REQUEST FOR ADDITIONAL INFORMATION (RAI) REGARDING BEAVER VALLEY UNIT Nos. 1 AND 2 LICENSE AMENDMENT REQUESTS Nos. 334 (UNIT 1) AND 205 (UNIT 2) :

Note: The following responses are applicable to Beaver Valley Unit 1 only.

Figure 1

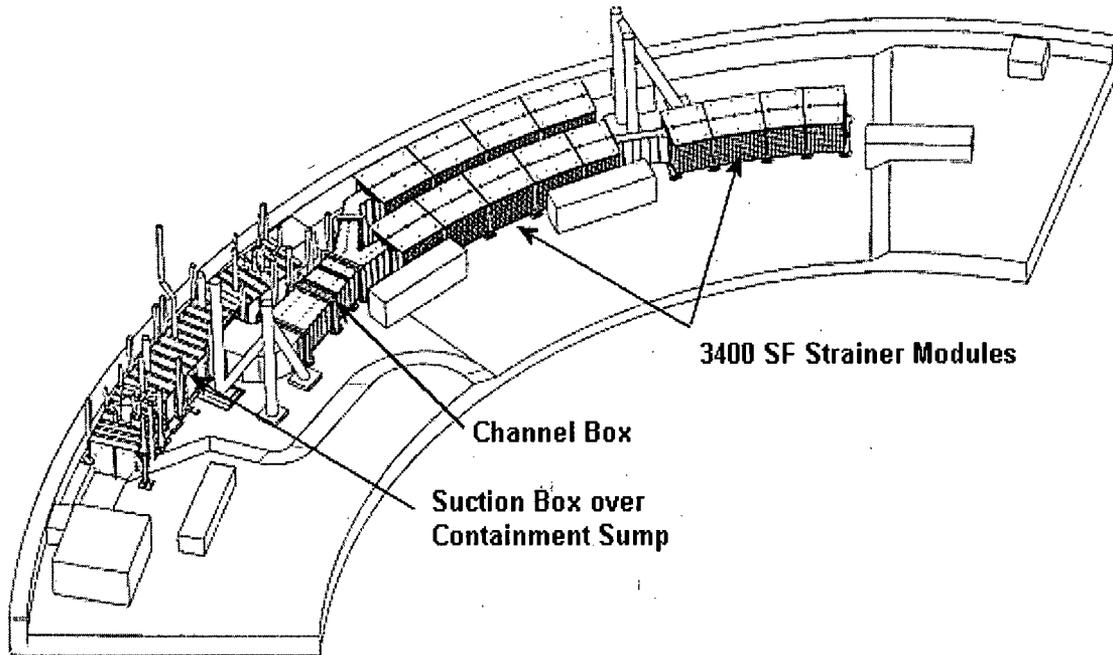
2. Provide a simple sketch of the layout showing the arrangement for the modified containment sump strainer assembly.

A simplified sketch is provided as Figure 1.

BEAVER VALLEY UNIT 1 CONTAINMENT SUMP STRAINER ASSEMBLY LAYOUT
